NOTICE OF ERROR
REPLY

Water right number: 91-7631

UNITED STATES OF AMERICA ACTING THROUGH
USDA FOREST SERVICE
550 W FORT ST MSC 033
BOISE ID 83724
Telephone Number: (208)365-7055

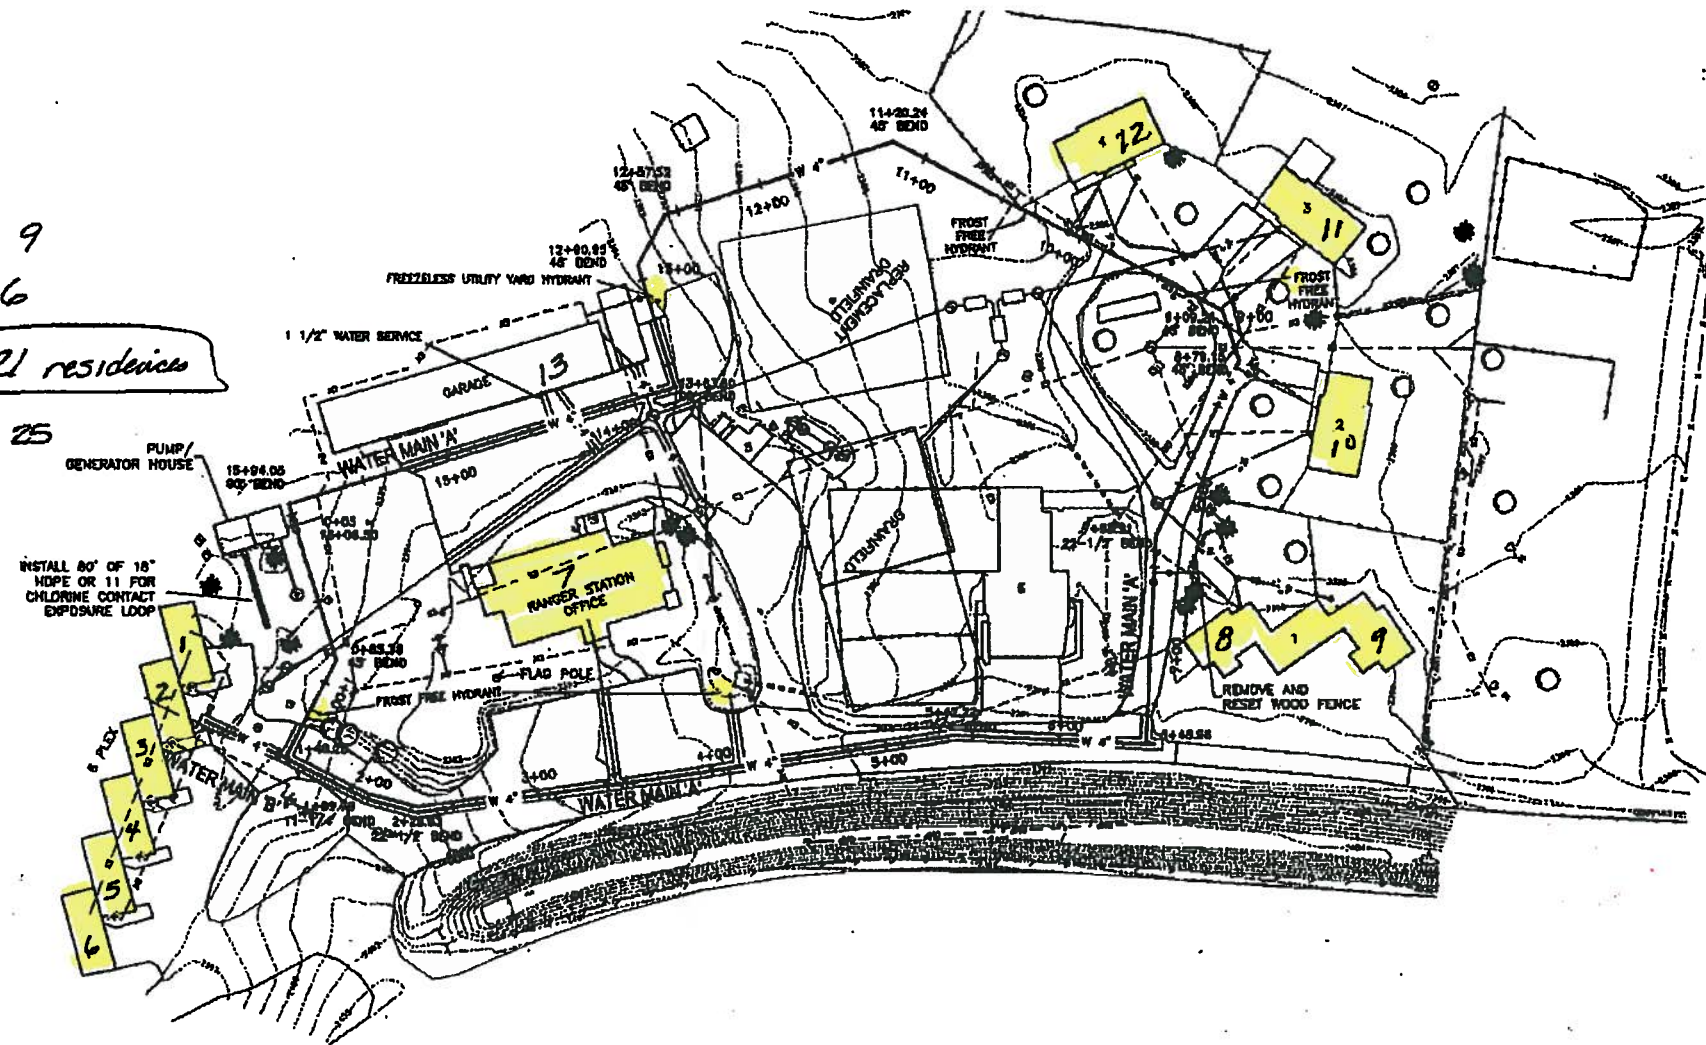
Avery Ranger Station includes an office, 3 residences, 1 duplex and a six-plex. These are numbered (10, 11, 12) (8, 9) and (1-6) on the accompanying site plat. There are also 4 frost free hydrants on the compound. BLM MTP shows all land north of the river in Sec 14 as Lot 3.

6plex - 6 people = 6.0
3 residence x 2.5/residence = 7.5 - 9
1 duplex x 2.5/residence = 5.0 - 6

19 - 21 residences

Quantity limited to 13,000 gpd.
POU T4SN R4E Sec 11 SESW Lot 3
Sec 14 SWSW Lot 4
NENW Lot 3
NW NW Lot 3
